MEMORANDUM

DATE: January 7, 2022
TO: Planning and Sustainability Commission
FROM: Eric Engstrom, BPS, Principal Planner Joan Frederiksen, BPS, City Planner
CC: Andrea Durbin, BPS, Director Cassie Ballew, BPS, City Planner - Urban Design Design Commission
SUBJECT: Draft amendments to the Proposed Draft of the West Portland Town Center Plan

West Portland Town Center Plan — Draft PSC amendments to Proposed Draft – January 2022

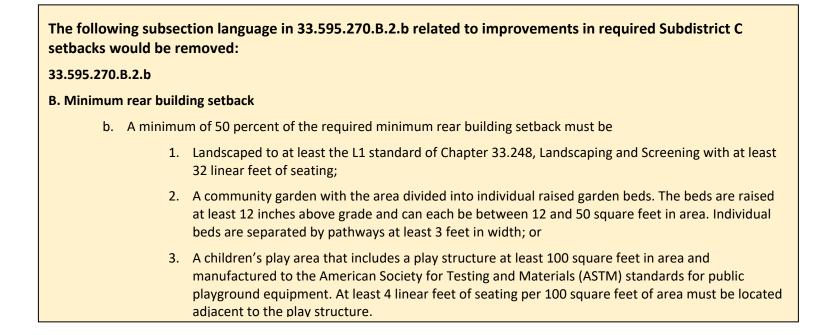
#6 DESCRIPTION: Remove the requirement for specific improvements within the required Subdistrict C setbacks.
